**Framatome Inc. Response to Request for Public Comment on the Draft Regulatory Guide DG-1327, "Pressurized Water Reactor Control Rod Ejection and Boiling Water Reactor Control Rod Drop Accidents" (Federal Register Vol. 84, No. 146, 36961, dated July 30, 2019; Docket ID NRC-2016-0233)**

**Enclosure 1:  
Framatome Comments on DG-1327**

Figure 1: Hydride-assisted PCMI-RIA failure mode from presentation of Reference 2

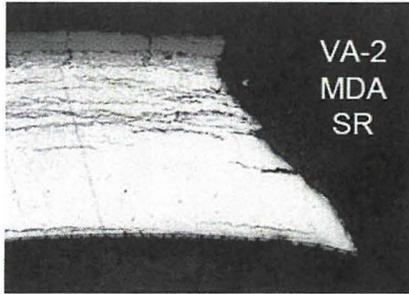
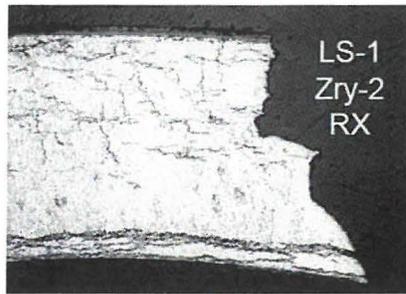
1. The PCMI failure mechanism during the initial stage of the RIA transient was identified to be the "outside-in" hydride-assisted cracking, for both SRA and RXA cladding types. As shown in Figure 1 below, taken from Reference 2, the crack initiation occurs at the cladding outer surface, where either a dense hydride rim (PWR, SRA cladding), or a highly connected hydride network with strong radial component (BWR, RXA cladding) develops with increasing exposure; the final crack propagation through the inner half region of the cladding is very fast, as it occurs under increasing stress intensification at the tip of the propagating crack.

Figure 2: Similar hydride-assisted PCMI-RIA failure mode for PWR (CWSR) and BWR (RXA) cladding types

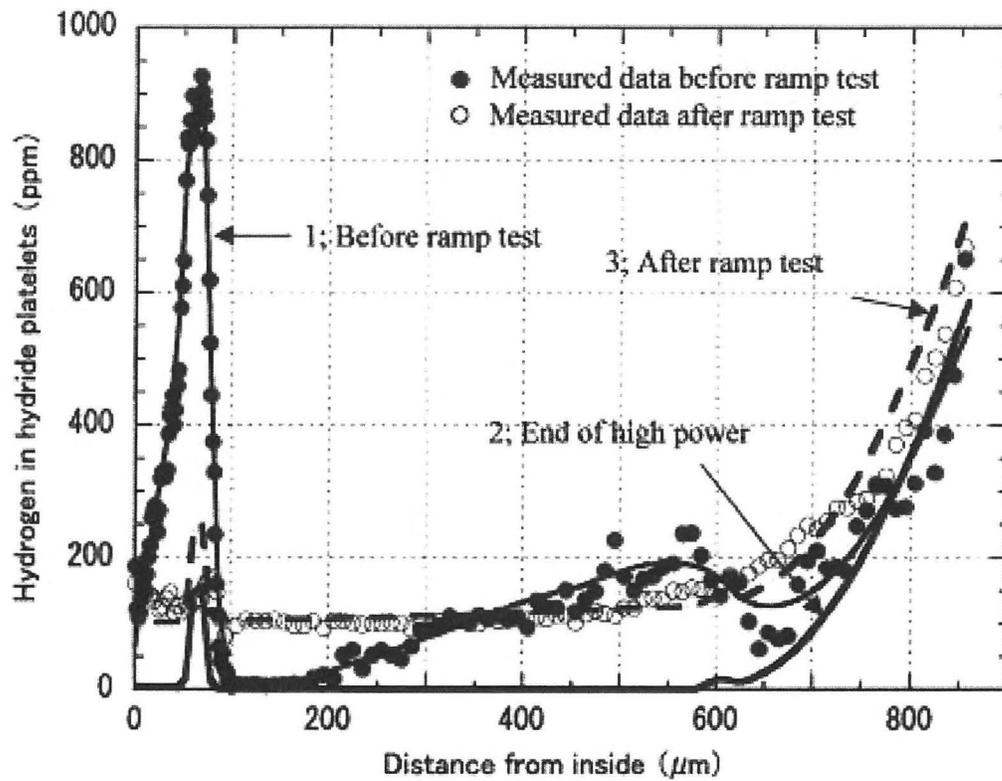
3. The overall cladding ductility has a negligible impact on the hydride-assisted outside-in cracking mechanism in the initial PCMI phase of RIA transients – this was documented in the PIE for the NSRR tests, which show typical final ductile failure due to the stress

intensification at the tip of the crack exceeding the ultimate tensile strength (UTS) (illustration in Figure 2)

Figure 4: Example PCMI Cladding Failure Threshold – Non-Liner RXA Cladding below 500 Degrees F

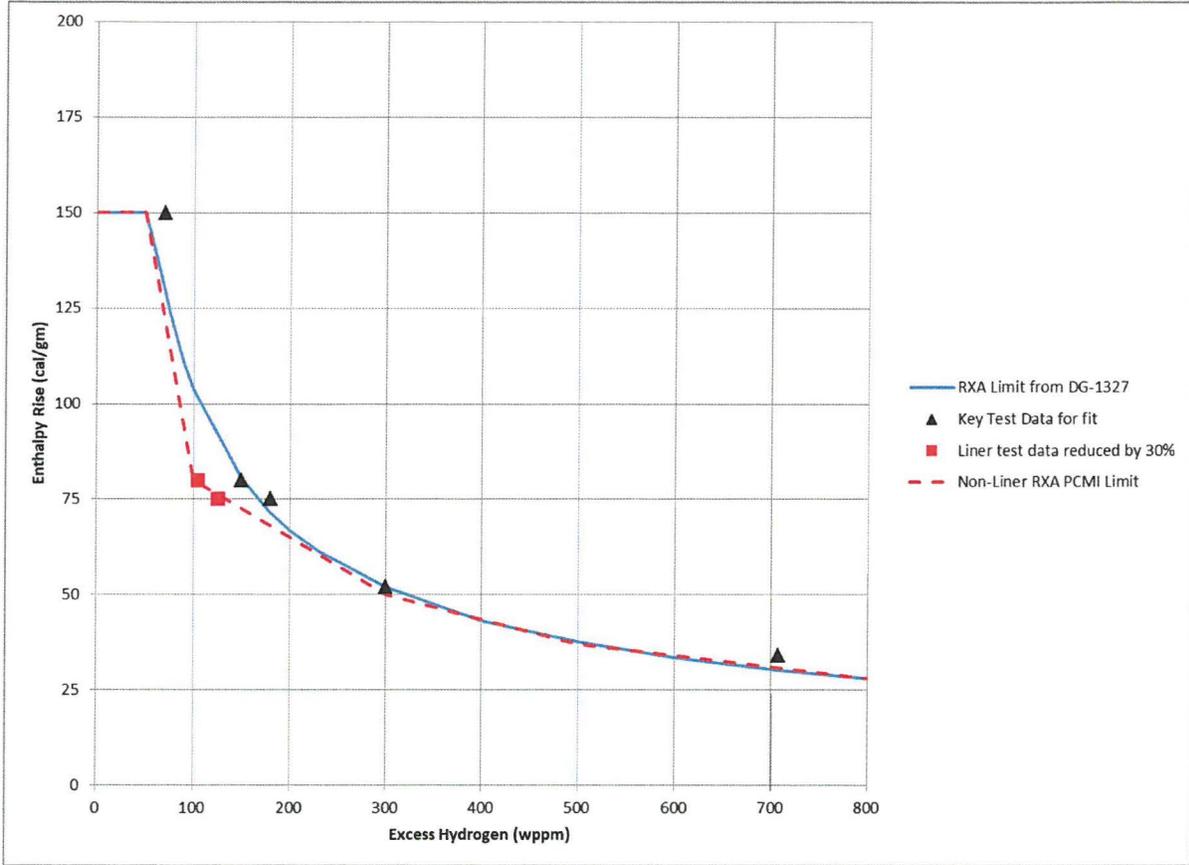
**Alternative Proposal:** If the proposal above is not considered an acceptable proposal, then revise Section 1.2.3 to provide adjusted PCMI limits for non-liner RXA cladding.

PCMI limit curves for non-liner RXA cladding materials can be developed by adjusting the hydrogen content of the liner RXA cladding tests to account for the influence of the liner on the hydrogen distribution in the bulk cladding material. Examples of adjusted PCMI limit curves are provided below in Figures 4 and 5.

Revised PCMI limit curves for non-liner RXA cladding can be developed by reducing the excess hydrogen content for the group of failed tests in the range of 150-200 wppm (see Reference 1, p. 47). Using this technique, PCMI limit curves are provided below in Figures 4 and 5. After the shift, the data points do not align well with a power function as proposed in Reference 1, p. 47. While more exotic function combinations could be used to fit the data, a simple, piecewise linear fit is provided in Figures 4 and 5.

Figure 6: Hydrogen Distribution from Hayashi et al (Reference 2)

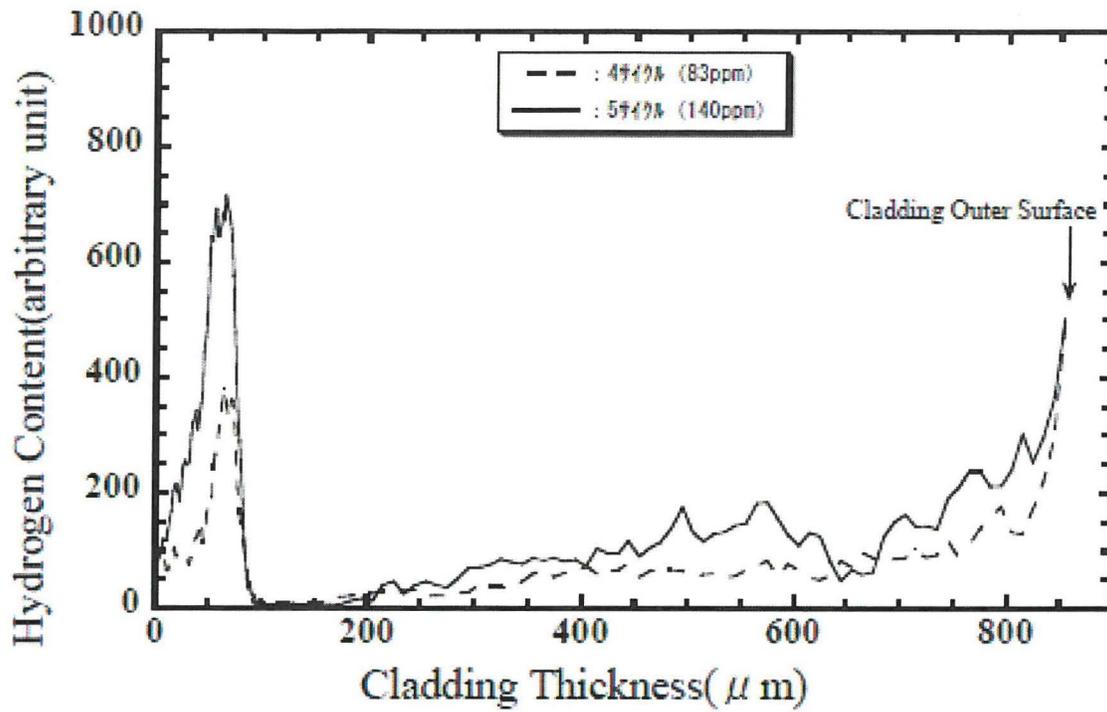
Hydrogen distribution through the cladding wall has been measured by Hayashi et al (References 3 and 4) and also in the NFIR-V project (References 5 and 6). Figure 6 shown below is taken from Reference 2 and demonstrates the preferential accumulation of hydrogen in the liner at the interface with the bulk cladding. These distributions (References 3 through 6) were used to evaluate the reduction in the bulk metal hydrogen concentration due to the soaking effect of the liner. On average, the soaking effect of the liner reduces the bulk hydrogen content by ~21% compared to the total hydrogen value. The upper bound is < 30% reduction. Figure 7 shows the results of the evaluation.

Figure 7: Hydrogen Concentration Reduction due to Linear Soaking Effect

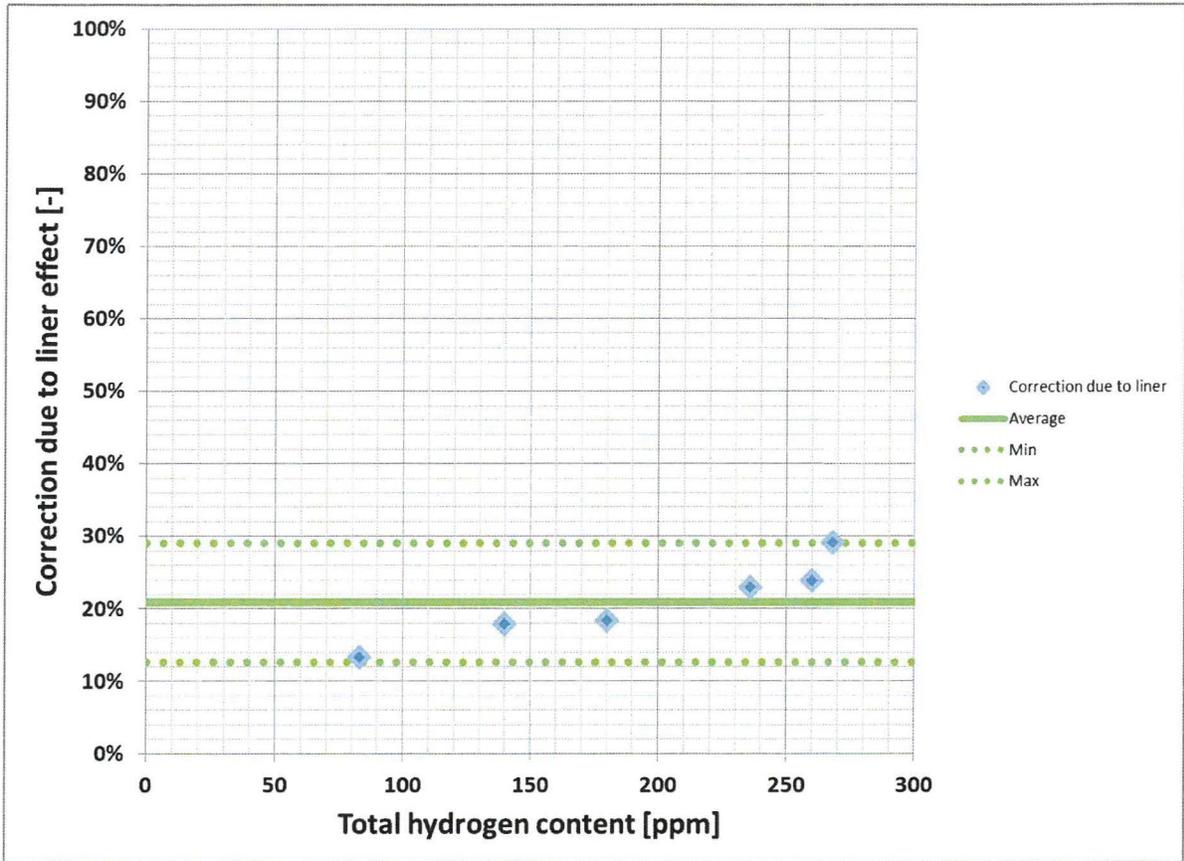
These results were also used to evaluate the hydrogen distribution in more than 30 Framatome proprietary metallographic cross-sections of lined Zr-2 RXA cladding from multiple BWR plants. The evaluation concluded that an upper bound reduction factor of 30% is conservative for total hydrogen content in excess of 800 wppm.
